UNITED STATES
DEPARTMENT OF THE INTERIOR
BUREAU OF LAND MANAGEMENT

SUNDRY NOTICES AND REPORTS ON WELLS
Do not use this form for proposals to drill or to re-enter an abandoned well. Use form 3160-3 (APD) for such proposals.

Read & Stevens, Inc. plans on Plugging and Abandoning the Hudson Federal #8 as follows:

RE: NMLC065607; Hudson Federal No. 8
1980' FNL & 1980' FEL, Sec. 4, T20S-R34E
Lea County, New Mexico

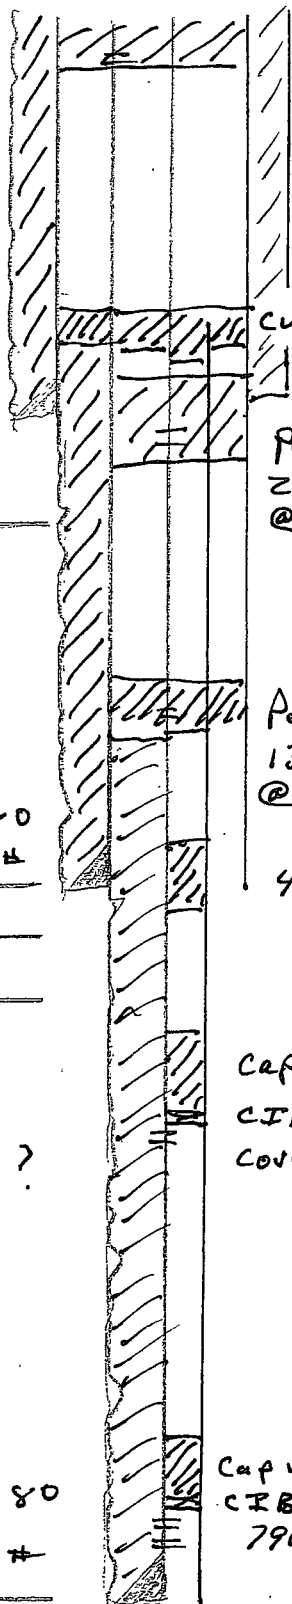
Knock out CIBP at 7400' (+/-)

A cement plug shall be placed opposite all open perforations and extend to a minimum of 50 feet below to 50 feet above the perforated interval. Plug #1 Spot 278' plug from 8222' – 7944', WOC and tag no lower than 7944. An option is to set a CIBP 50' -100' above the upper most perforation (7944- 7894') and cap with 35' utilizing a dump bailer, or by spotting a 25 sack minimum plug on top of the CIBP.

Plug #2 Spot 160' (5750' – 5590') plug across the open Delaware perforations at 5663' – 5678'. WOC and tag no lower than 5590'. Plug #3 would require a 150' plug to cover the top of the Delaware formation (5360'), from 5435' - 5285'. Suggest setting a CIBP @ 5613' – 5563' (50-100' above the uppermost perforations), and capping with a 310' plug to cover the open perforations and the top of the Delaware. No tag required.

Plug #3 Spot 150' plug from 4966' – 4816' (25 sack minimum) across the 8-5/8" casing shoe. WOC and tag no lower than 4816'.

Plug #4 Perforate 5-1/2" casing @ 3280' and attempt to squeeze a 130' (cover the top of Yates, considered by NMOCD as Base of Salt) plug in/out of the 5-1/2" casing. WOC and tag no lower than 3150'.

Plug #5 Perforate 5-1/2" casing @ 1710' and attempt to squeeze a 220' (covers the top of Salt and the 13-3/8" shoe) plug in/out of the 5-1/2" casing. WOC and tag no lower than 1490.

Cut and pull the 5-1/2" casing @ 1280'.

Spot stub plug from 1330'-1230'. WOC and tag no lower than 1230'.

Perforate 8-5/8" casing and attempt to squeeze a surface plug from 60', in and out of the 8-5/8" bringing cement to surface.

cut/pull TOC SURF Circ.
1280 Stub plug INT W.K.
1330 - 1230 Tag PROD W.K.

Perf @ 1710 Sp
220' WOC Tag
@ 1490 (shoe & top salt)

Perf @ 3280 Sp
130' plug WOC Tag
@ 3150 (Yates)

4966 - 4816
WOC Tag

Cap w/ 310' cmt
CIBP @ 5550 +/-
Covers Perfs & Top Delaware

Cap w/ 35' DB or 25 SX plug
CIBP @ DVT UNKNOWN Depth
7900 +/-
